NUCLEAR REGULATORY COMMISSION

In the Matter of: ADVISORY COMMITTEE ON REACTOR SAFEGUARDS
270TH GENERAL MEETING

DATE: October 8, 1982 PAGES: 268 - 399
AT: Washington, D. C.

PRESSURIZED THERMAL SHOCK
PRESENTATION TO THE
ADVISORY COMMITTEE ON REACTOR SAFEGUARDS

EXAMPLE OF NRC PRESCRIPTION FOR RT_{NDT} (FOR ASSUMED $RT_{NDT}(o)$ OF $0^{\circ}F$)

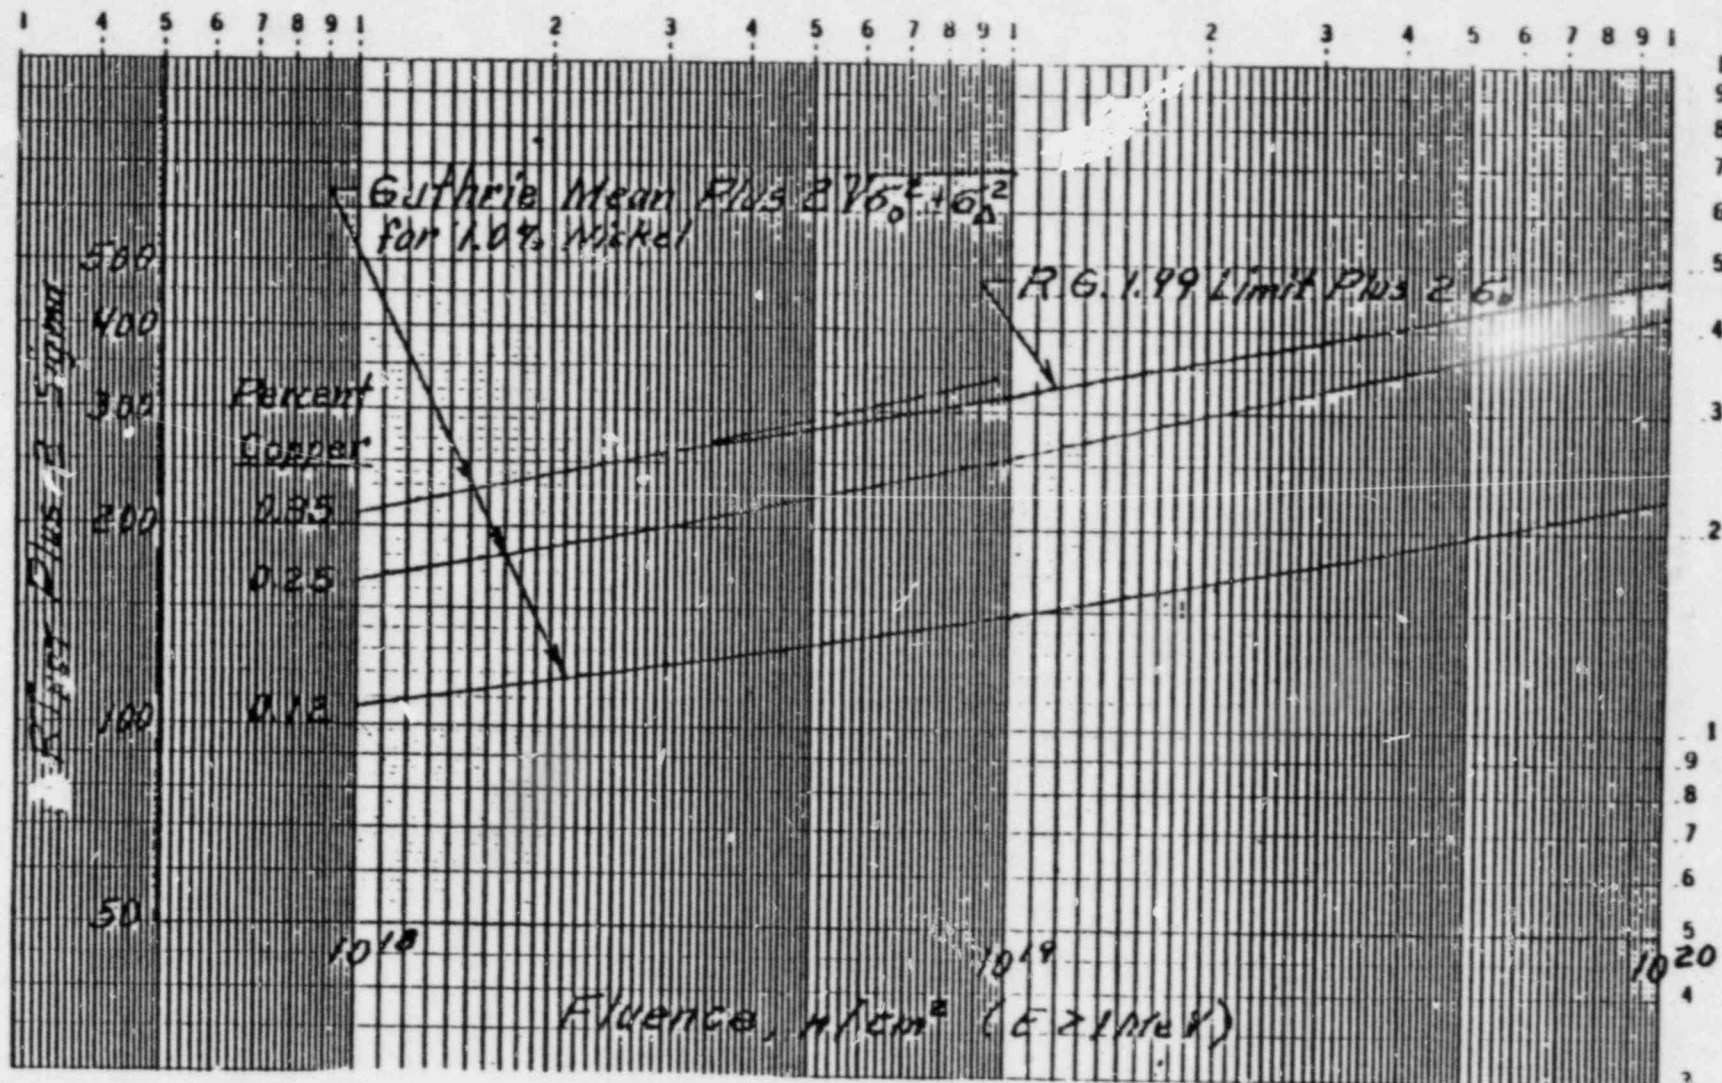
23 I am unable to reproduce the arithmetic on
24 your Chart 14 which calculates the RT for the
25 plants. NDT

8 MR. LEWIS: The top row doesn't add up to the
9 last number in the row.

10 MR. SHEWMON: Take 56 from 295 and then add
11 34.

FIGURE 8-3

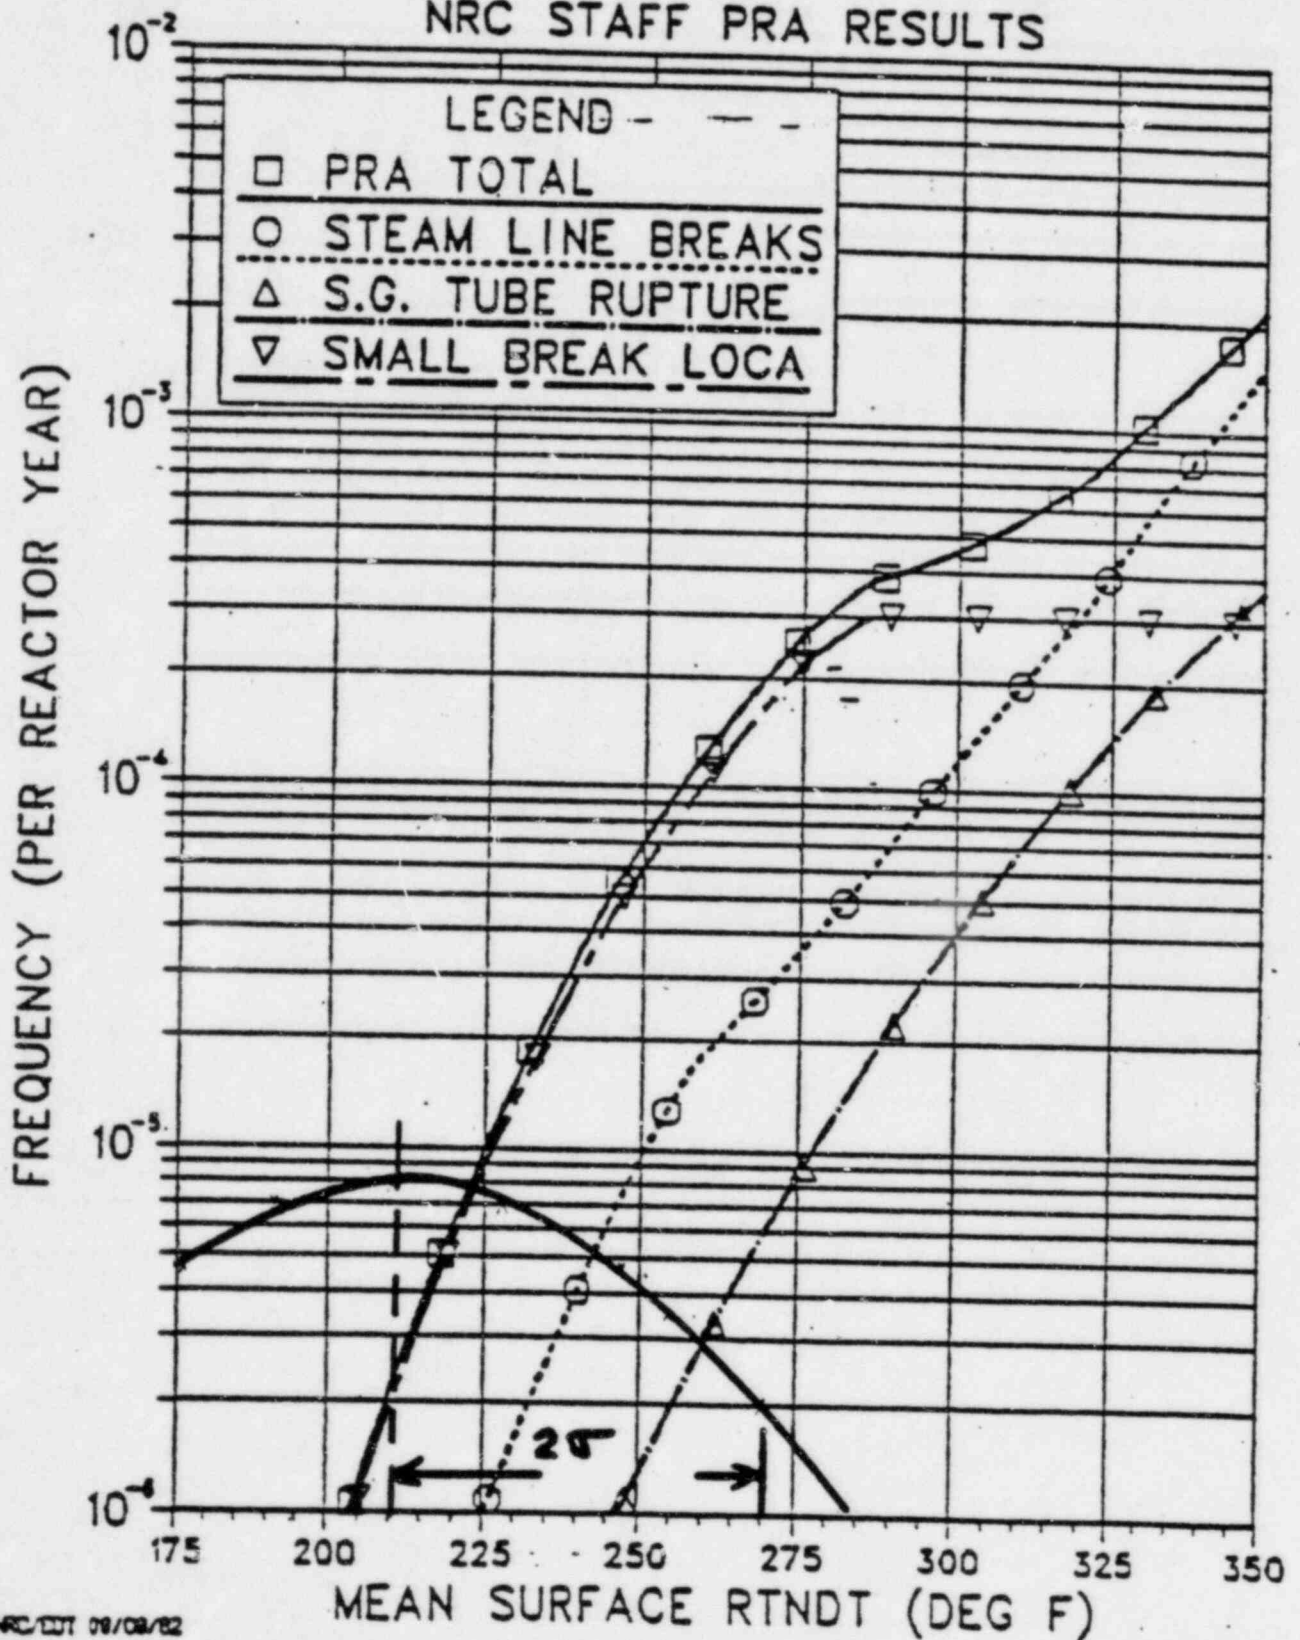
13 MR. MARK: Perhaps Israel or perhaps Steve, I
14 learned from figure 22 that steam line breaks are rather
15 more probable than 10^{-1} and that I find surprising.

16 MR. HANAUER: Steam line breaks, I do not see
17 how you learn it from figure 22, but they are --
